Orient Allure Lingerie Ltd. Tiffiny's Wear Ltd. Saville Row Ltd. LZ Textiles Ltd.

Dewallia Bari, Konabari, Gazipur, Dhaka
(24.01162N, 90.31014E)

4 March 2014

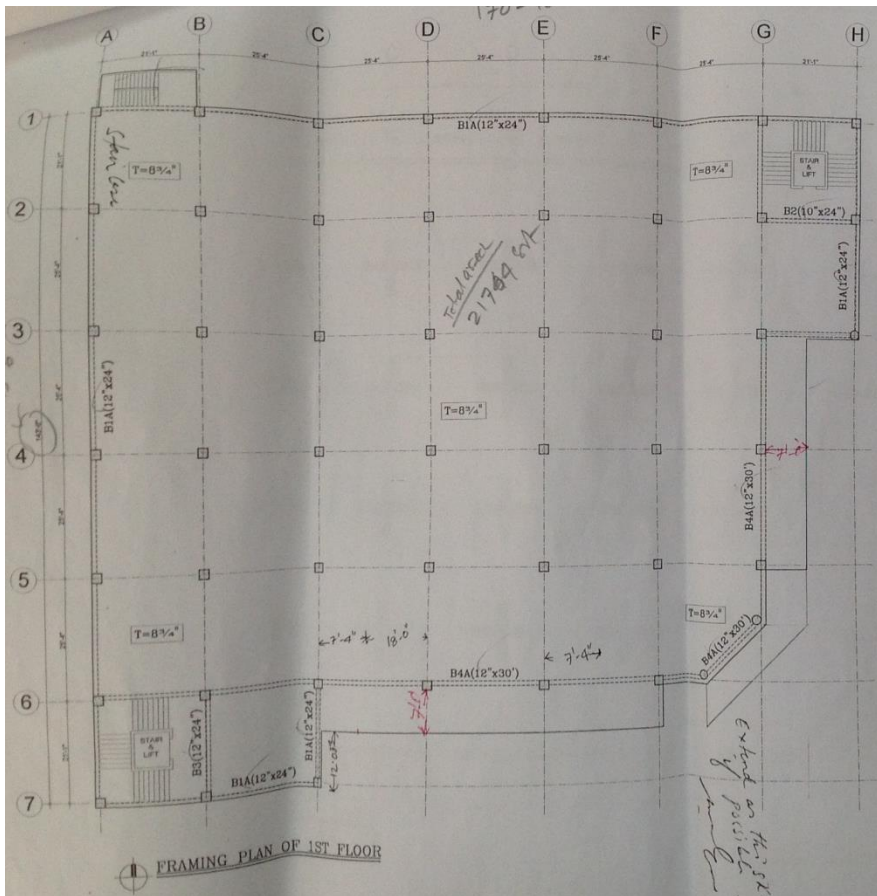
**Design check required for floor build-up loading
in wash and toilet areas to confirm floor slab load
capacity**

500mm high floor build-up in toilet area supported by concrete slab.

Building Engineer to check that the slab has been adequately designed to carry floor build-up loads

Floor plan on structural engineer's drawing

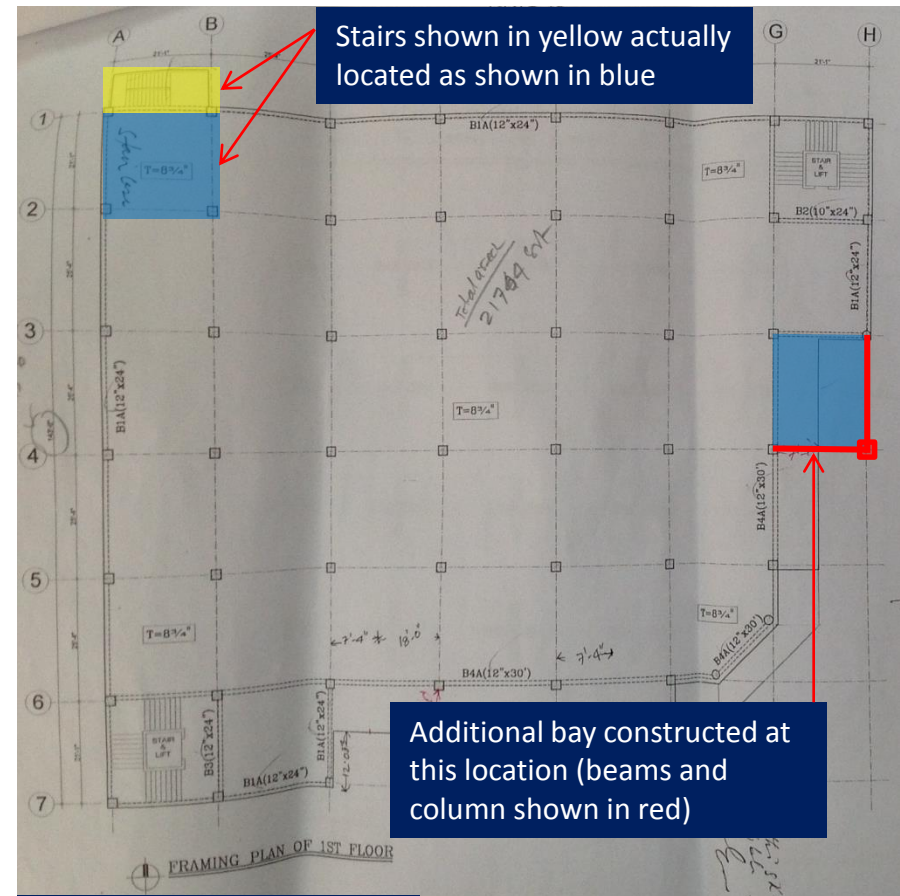
Minor inconsistencies between structural drawings and the as-constructed structure

Discrepancies between structural engineers' drawings and as-built structure.

Structural Drawings

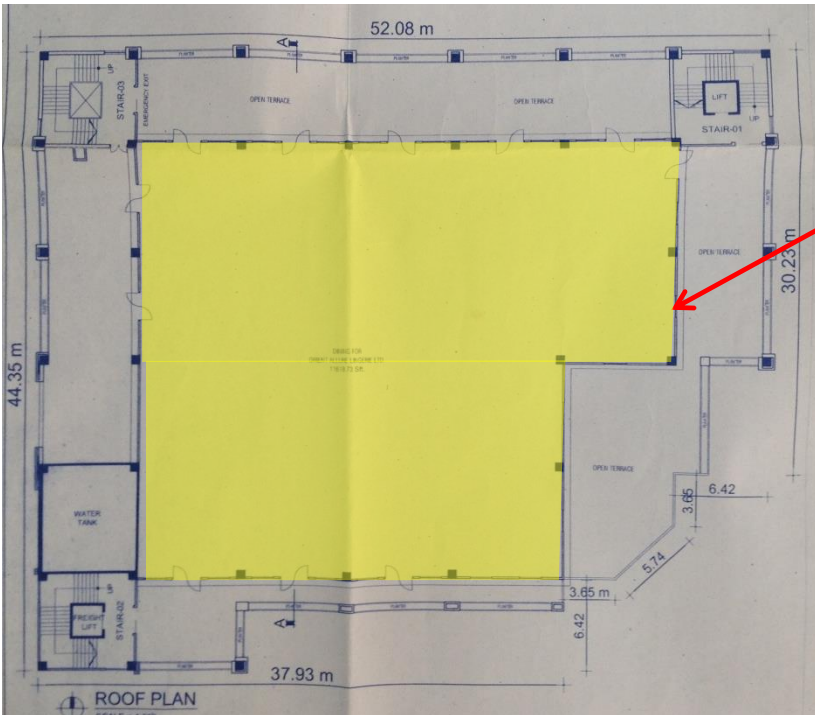
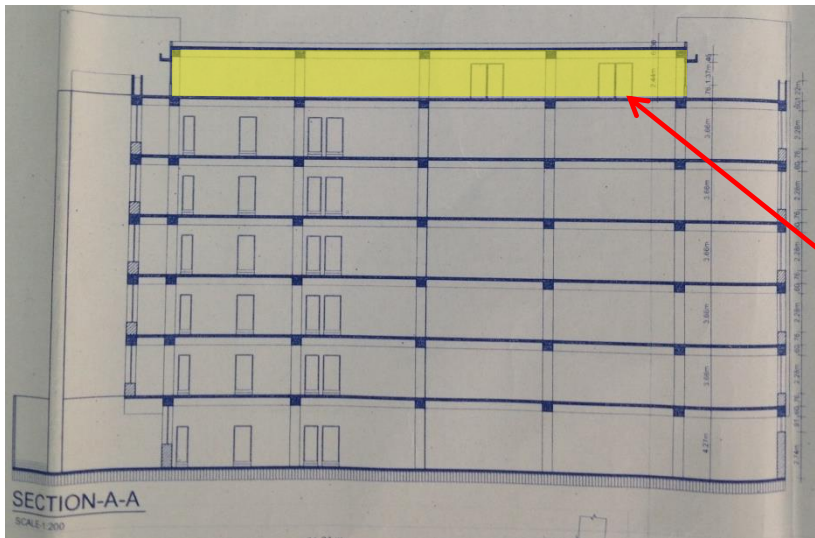
Any proposed additions to the existing building structure, including the proposed roof structure, should be reviewed by the Building Engineer.

**Additional roof structure
at location shown should
be reviewed by the
Building Engineer**
